From: [REDACTED]
Sent: 28 April 2025 16:35
To: planninginfo
Subject: DM/25/0014, DM/25/0015, DM/25/0016 and DM/25/0017

These comments follow review of the various updated documents associated with the planning application DM/25/0014 , DM/25/0015, DM/25/0016 and DM/25/0017. All planning numbers noted above are relevant for the comments below.

Re: Framework Travel Plan

3.3.1 Bus

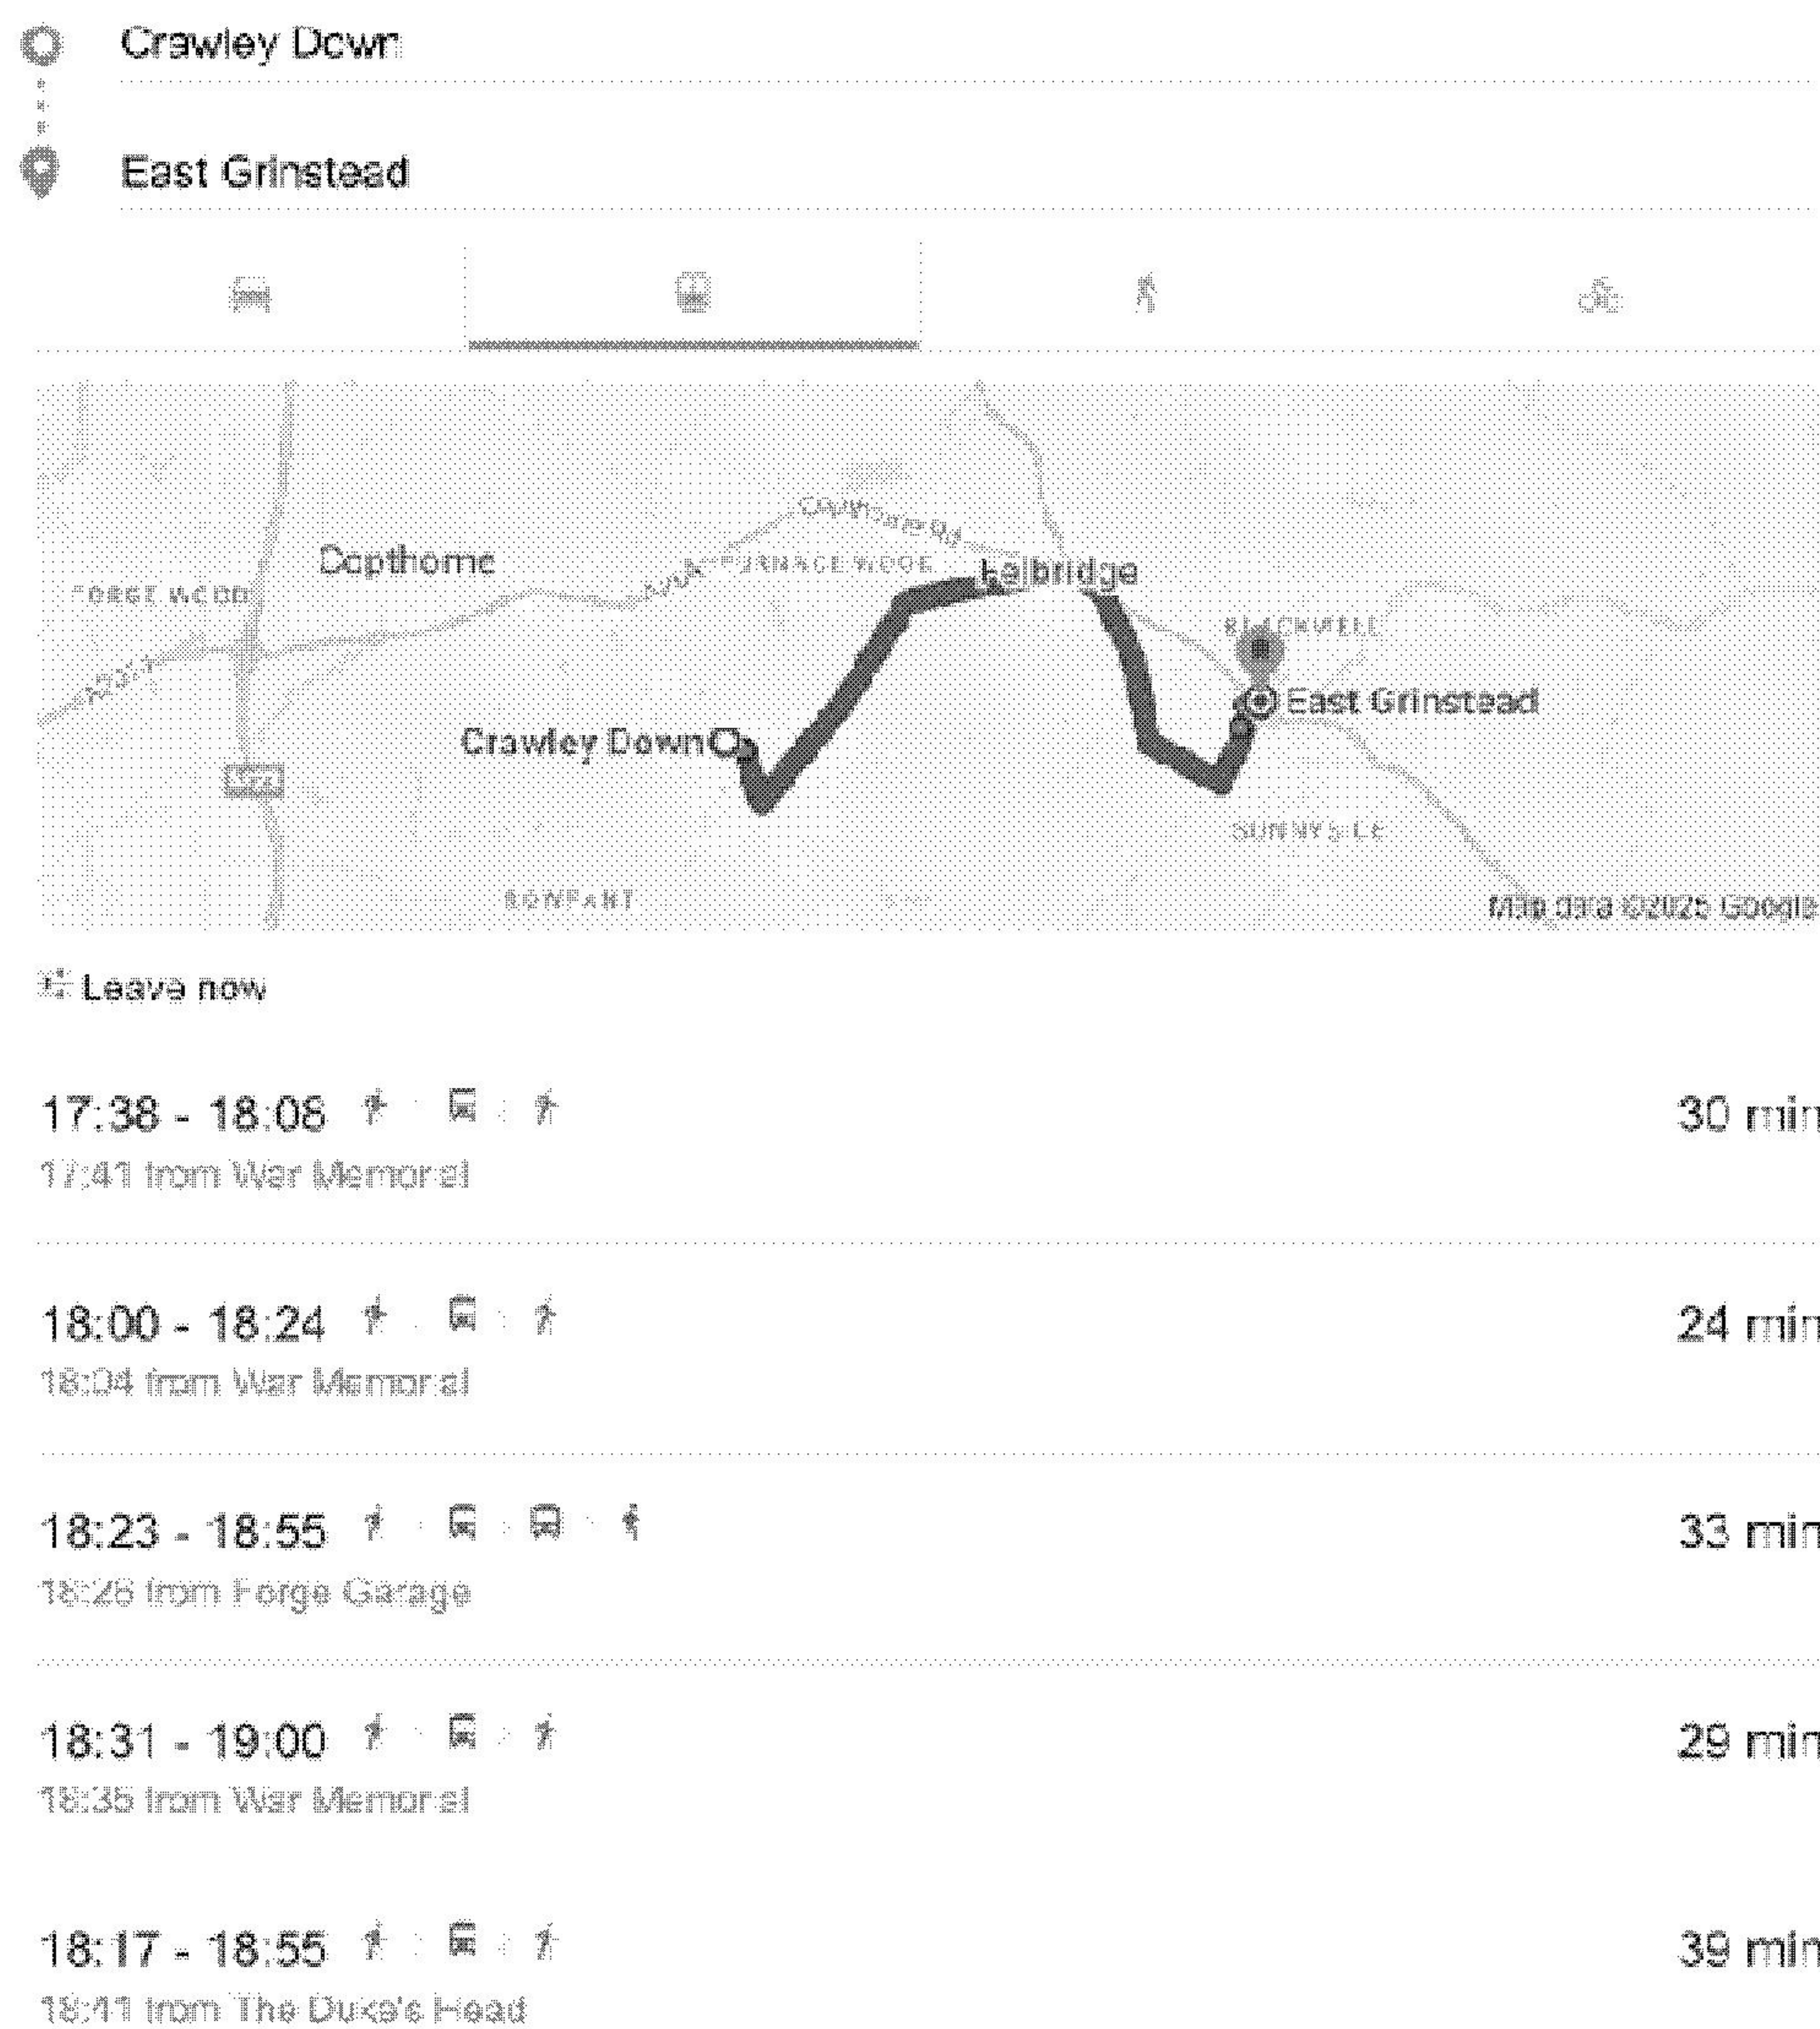
Bus stops described as 600m from 'the site'. Is this misleading?

The site itself is approx. 700m East-West the bus stop is therefore a 10 – 15 minute walk away from the 'average' house location on this site.

3.3.7

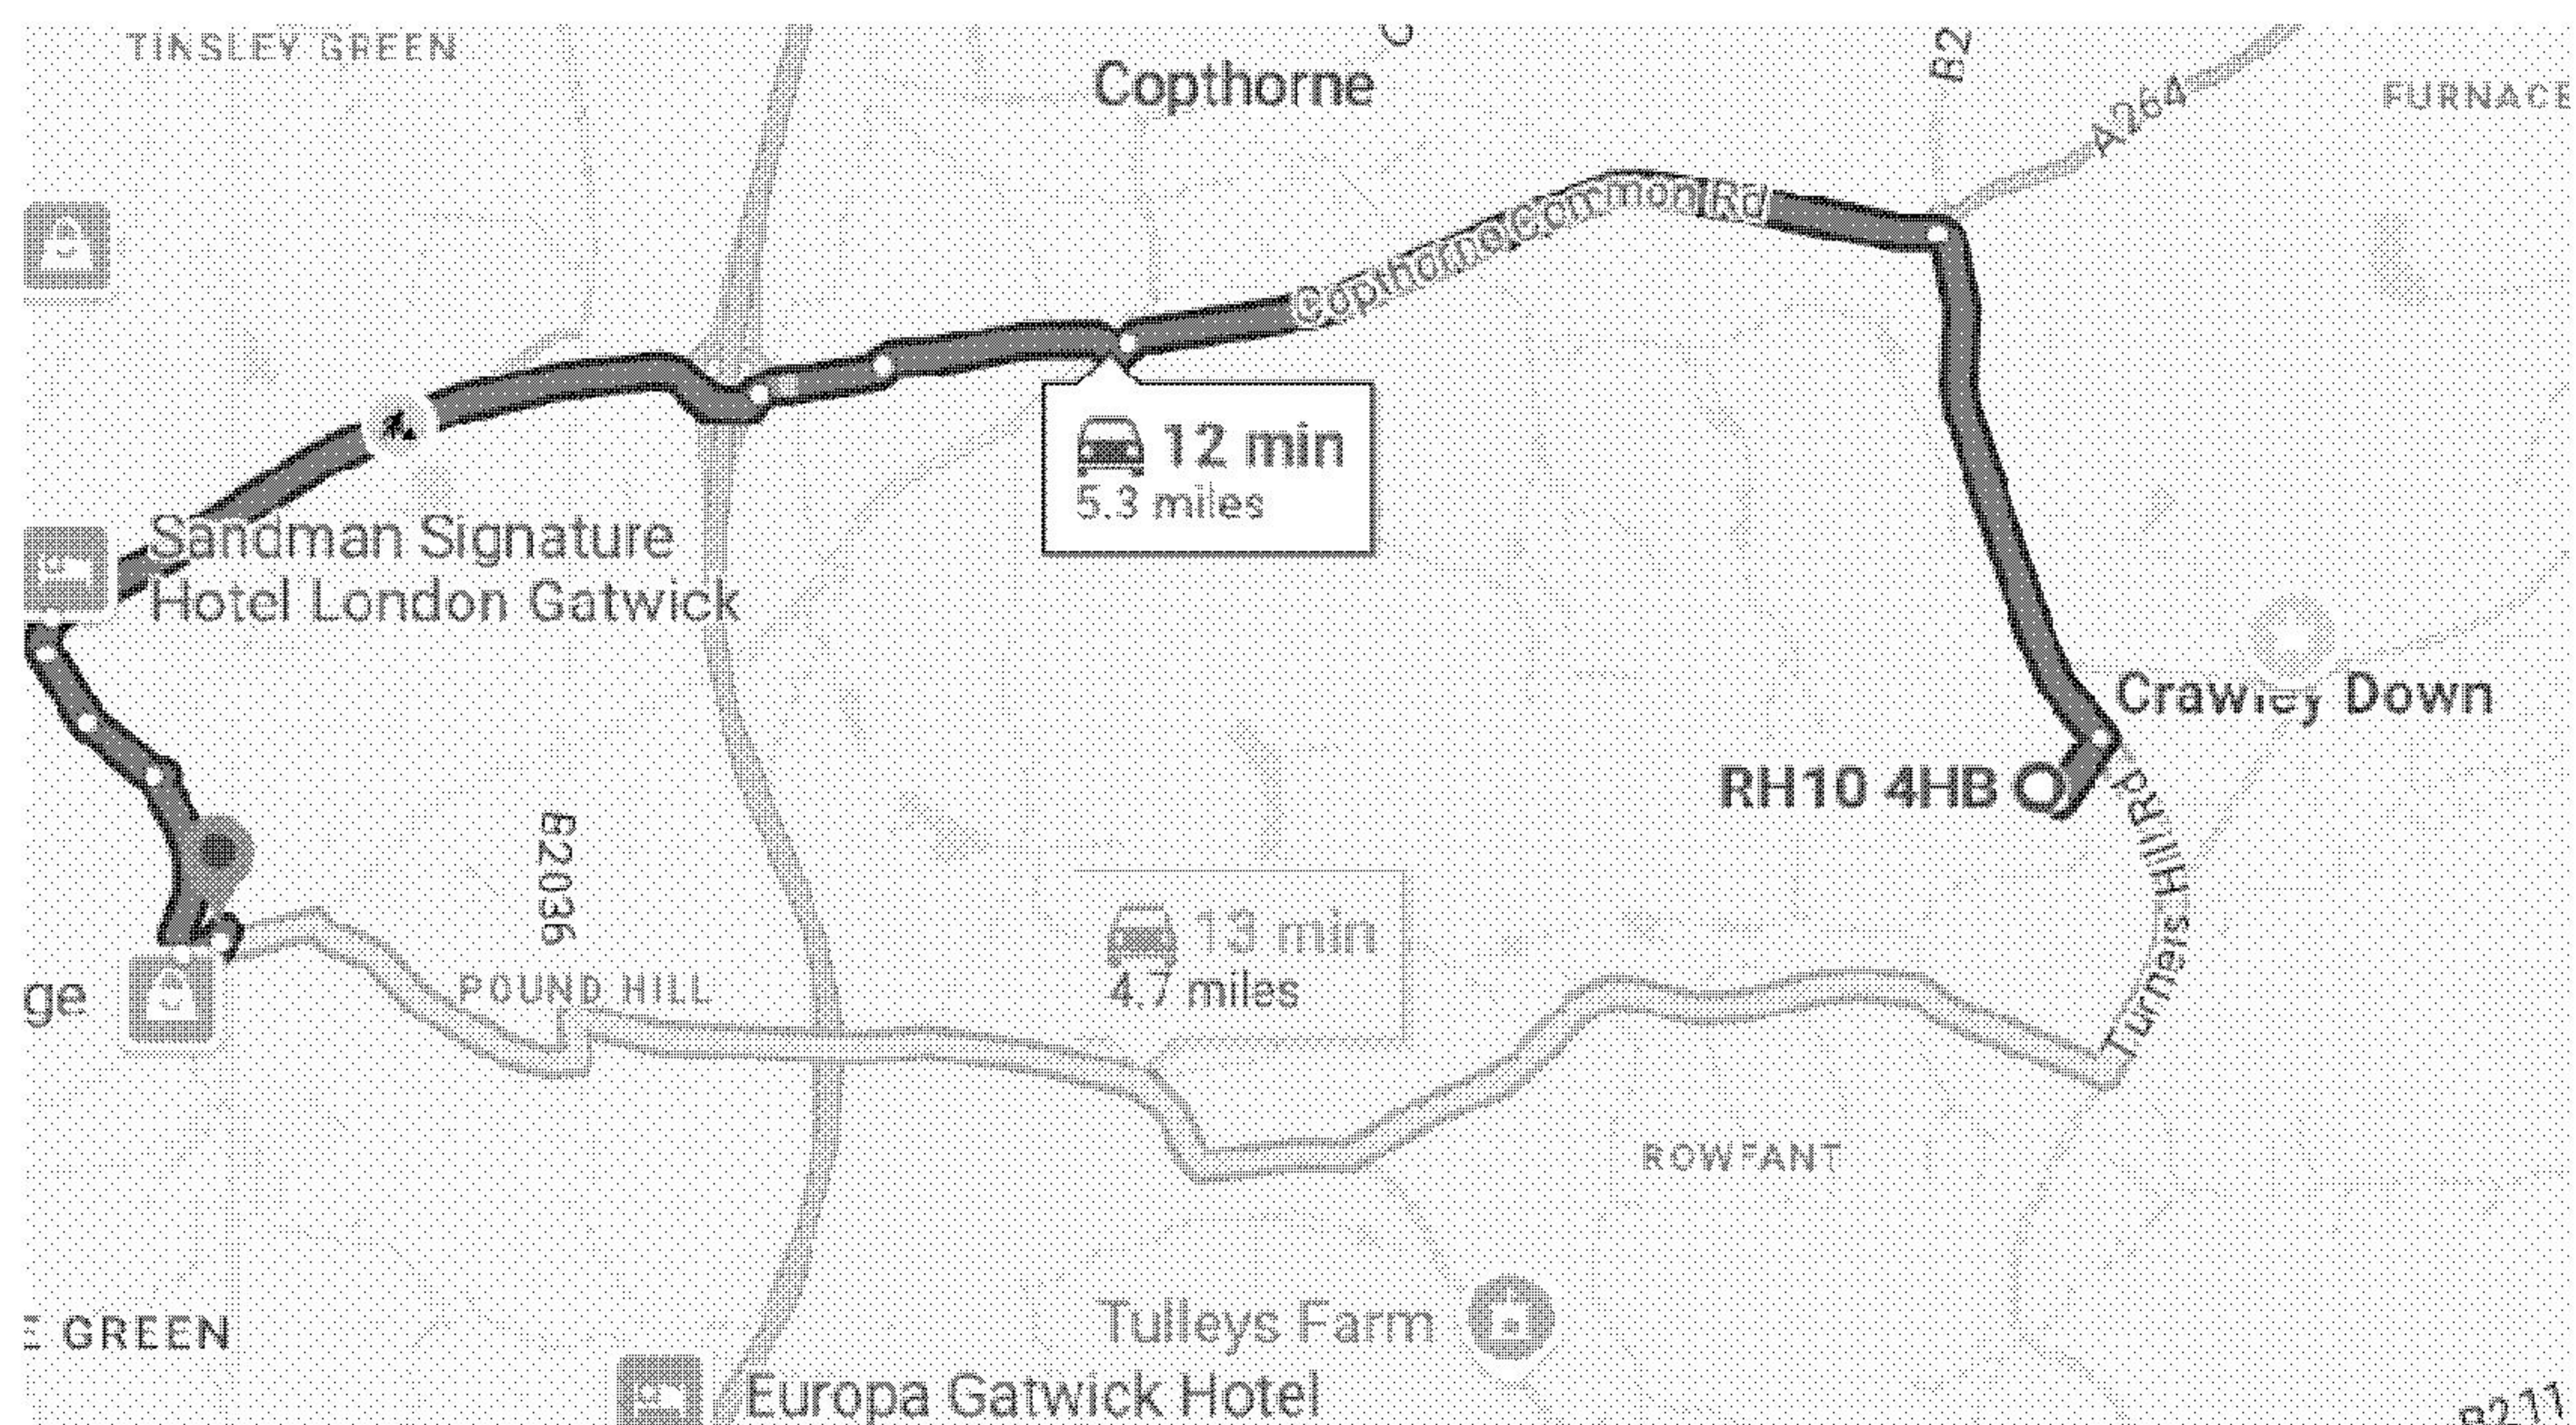
Inaccurate distances stated 'approximately 5km to Three Bridges station'. It is in fact 7.6km (4.7miles shorter journey shown below).

3.38

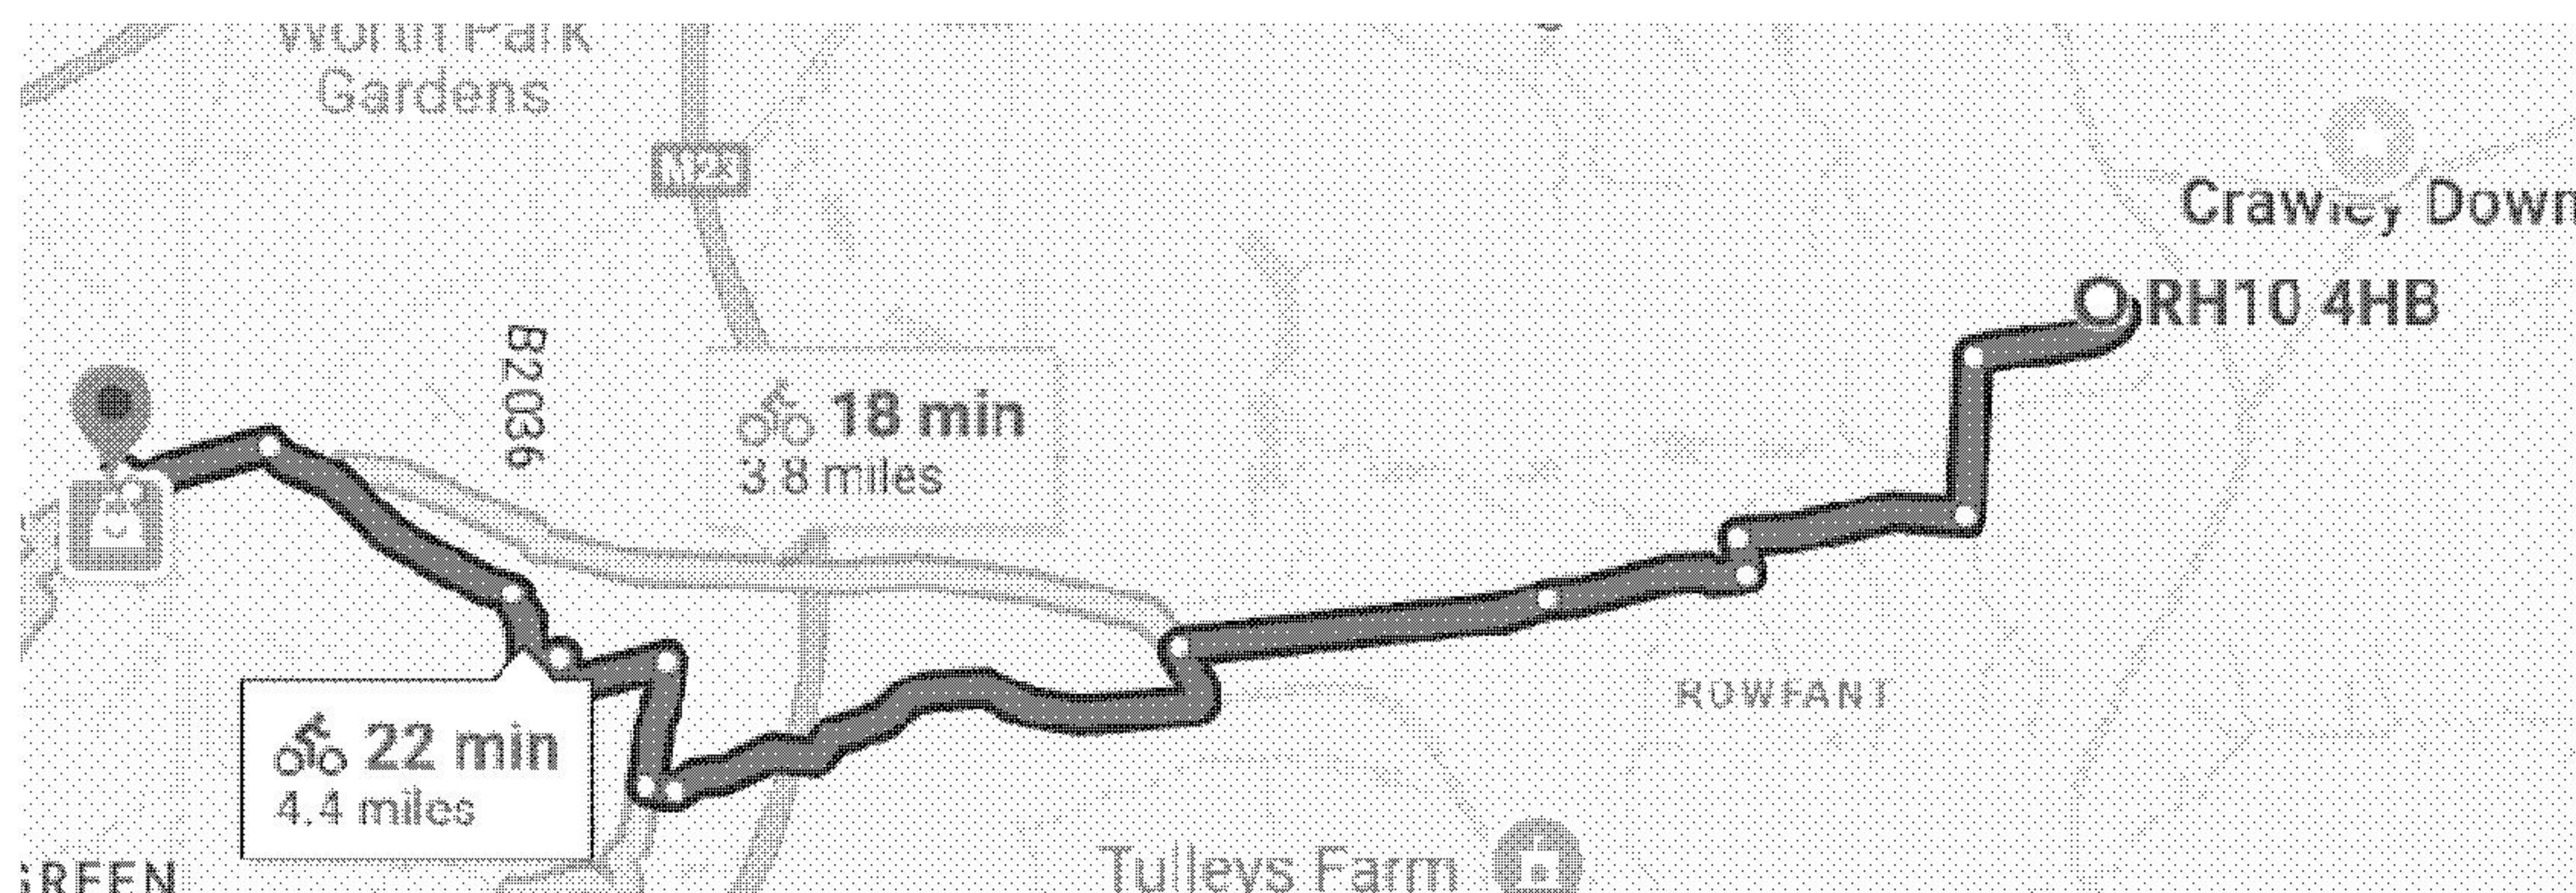
Inaccurate data claimed about cycle time to Three Bridges station:

“ Three Bridges and East Grinstead are accessible by bike via Worth Way (approximately a 15-minute cycle ride to Three Bridges “

See below for estimate of 22 minutes to Three Bridges along the Worth Way from Huntsland
